**ASHLAND PLANNING COMMISSION  
REGULAR MEETING  
JANUARY 10, 2011  
AGENDA**

**A. PLANNING ACTION: #2011-01576**

**SUBJECT PROPERTY: 1554 Webster Street** (*on the Southern Oregon University campus*)

**ASHLAND PLANNING DIVISION  
STAFF REPORT ADDENDUM  
January 10<sup>th</sup>, 2012**

**RECOMMENDED PEDESTRIAN IMPROVEMENTS AT THE WIGHTMAN-INDIANA STREET INTERSECTION  
ASHLAND, OREGON**

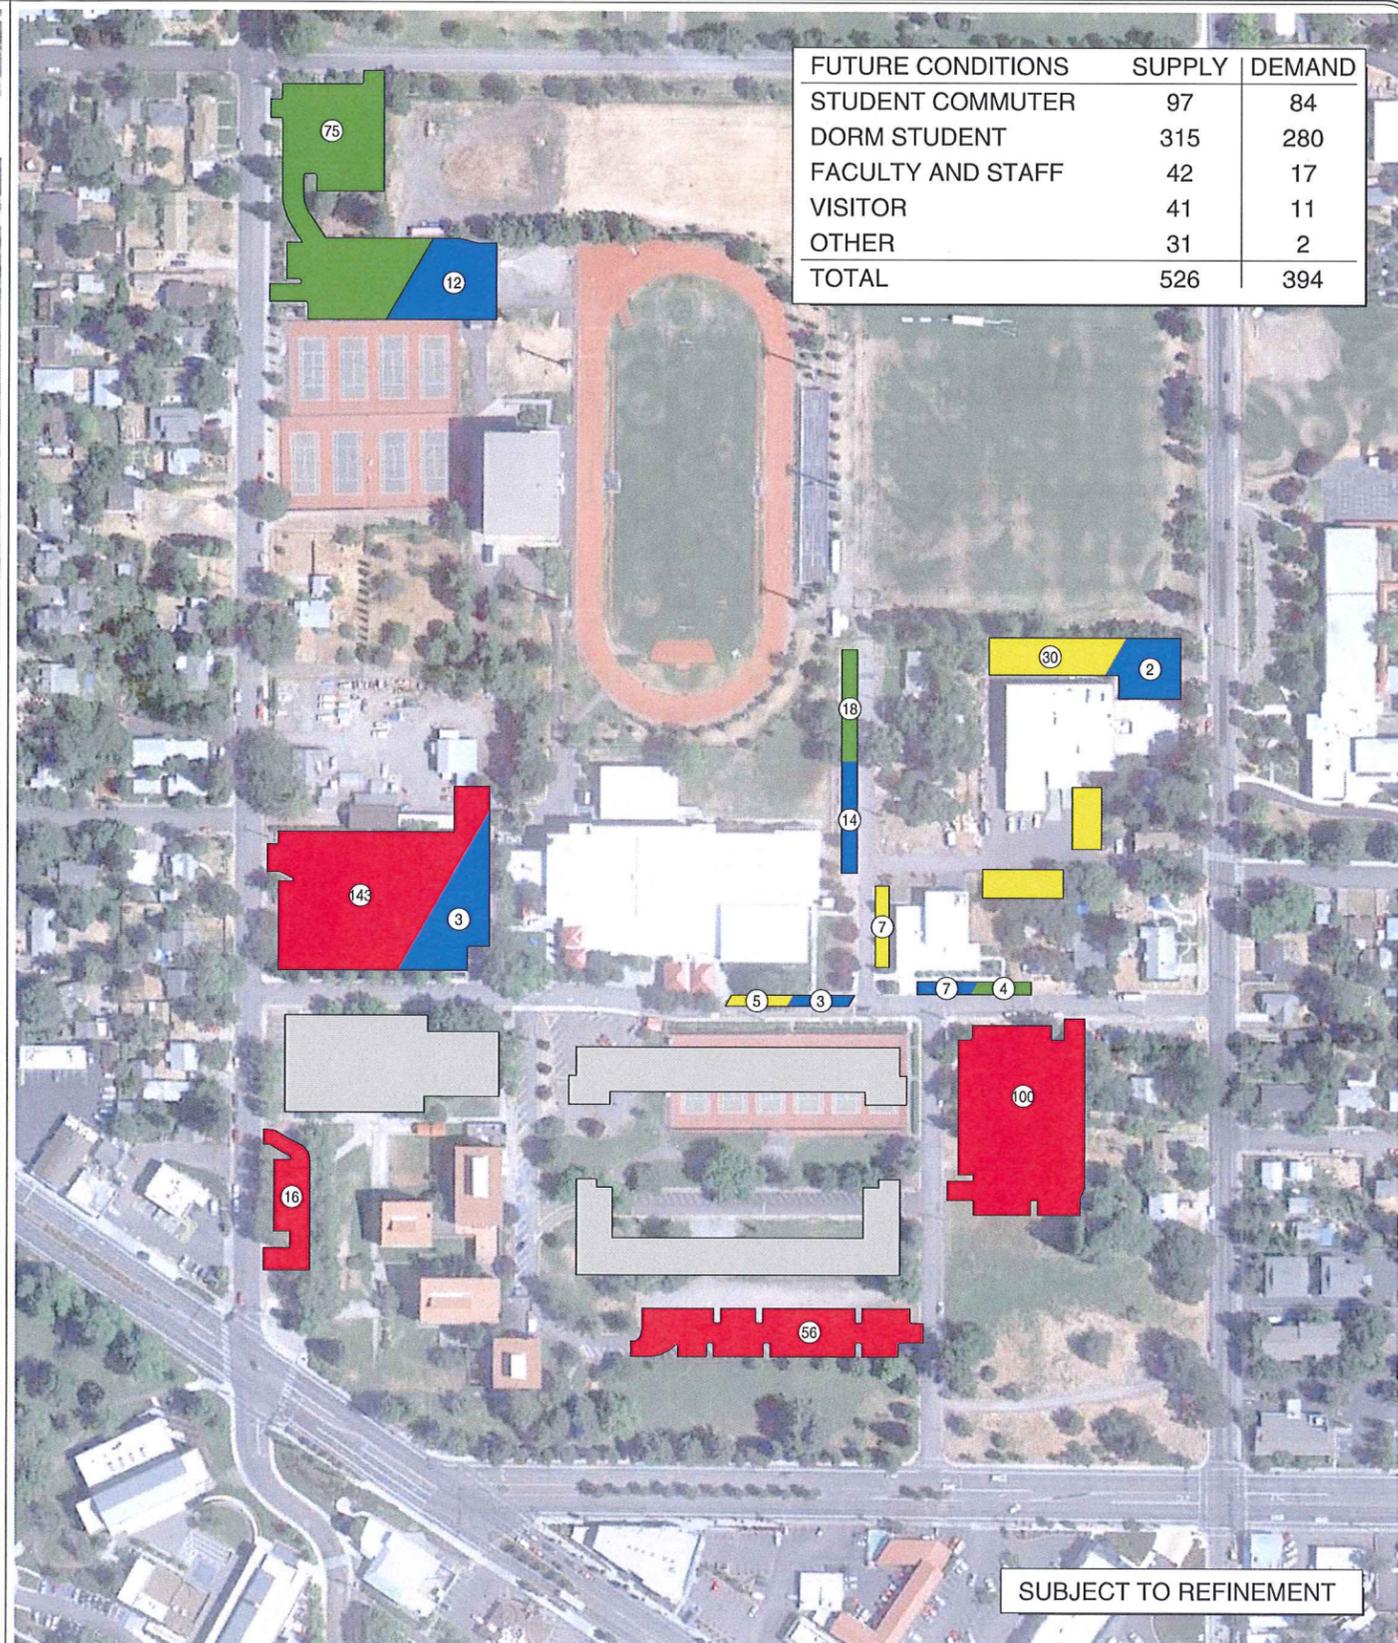
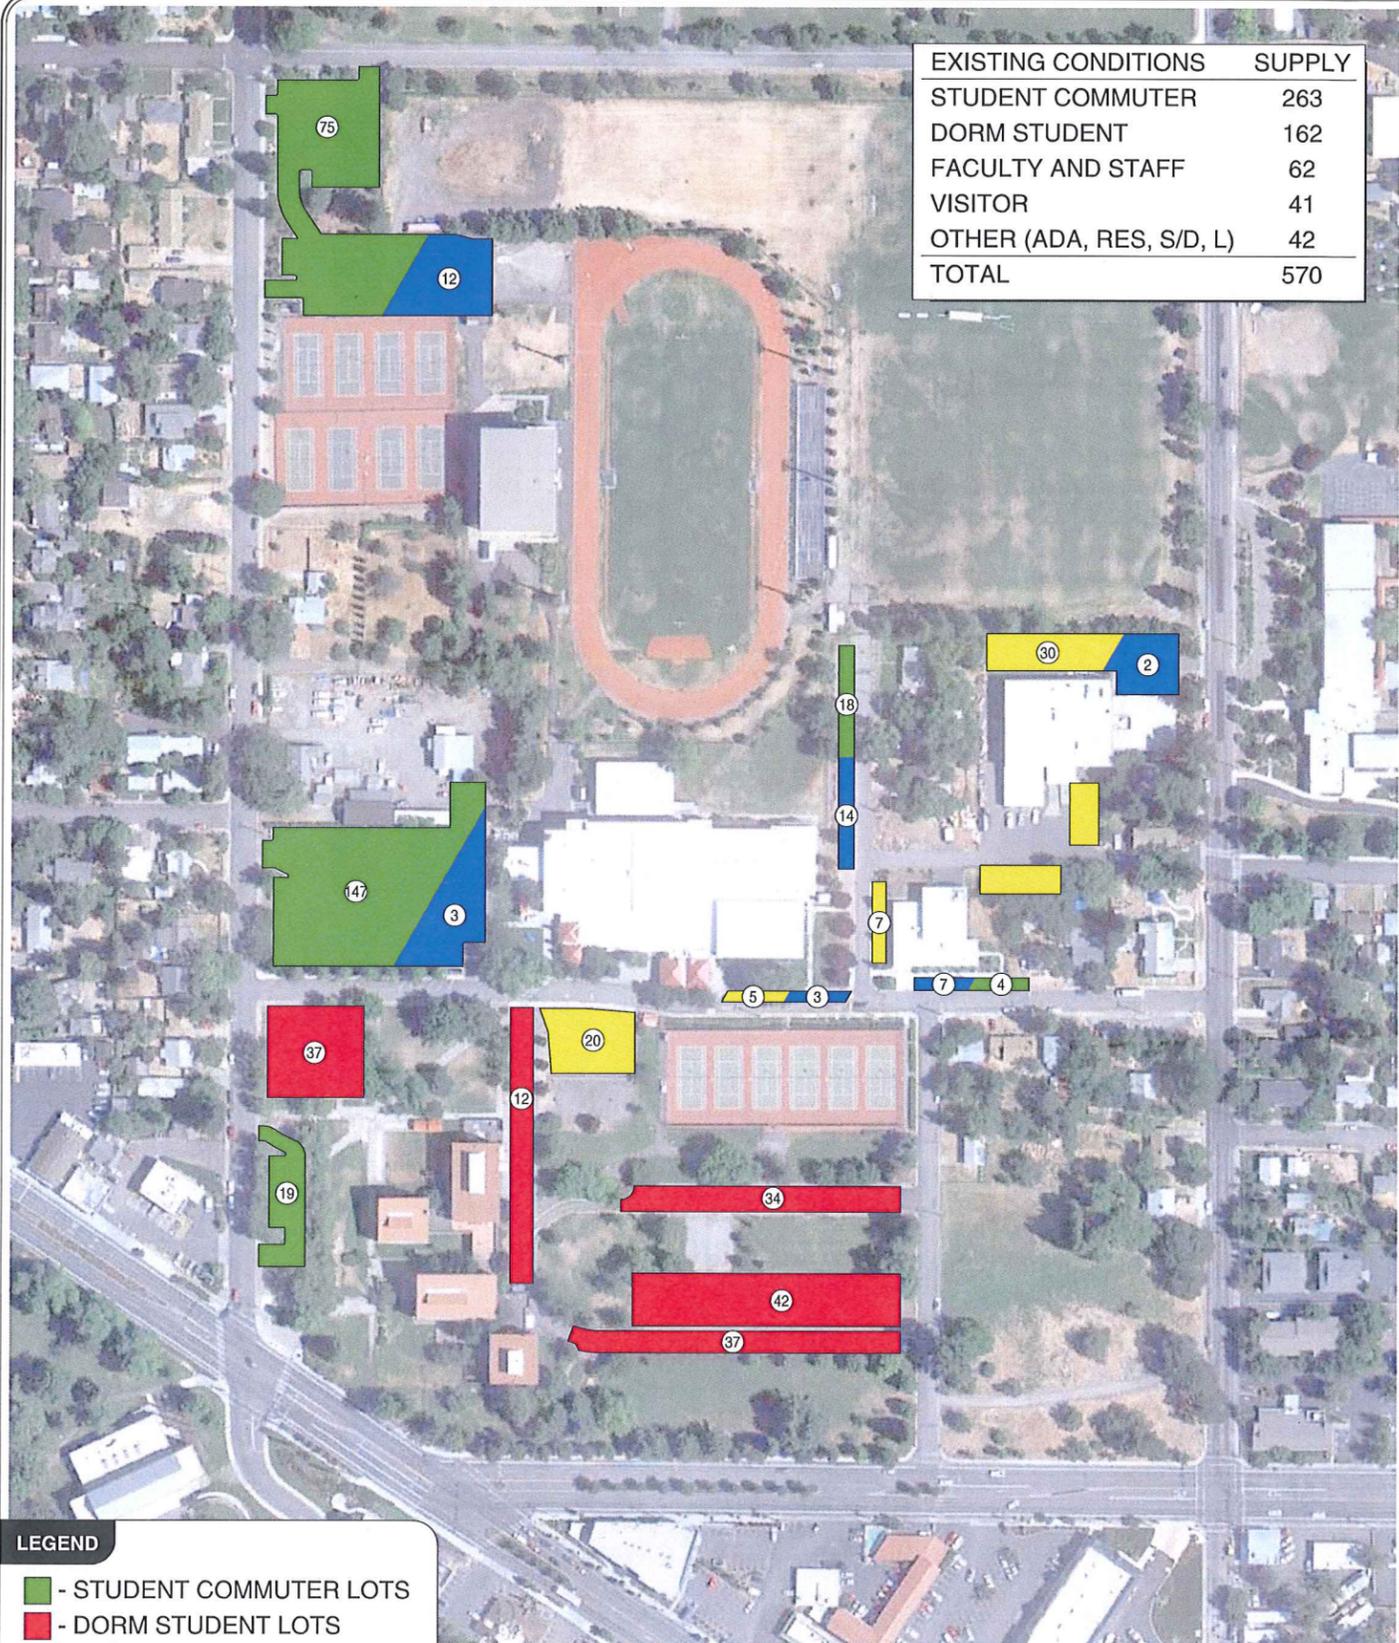
- 1) Replace Pedestrian Heads with Audible Pedestrian Countdown Heads
- 2) Design and Reconfigure the intersection with single crosswalk as shown conceptually on new Figure 12 (see attached); upgrade existing controller at both Wightman and Hwy 66
- 3) Install high visibility pavement marking for diagonal crosswalk
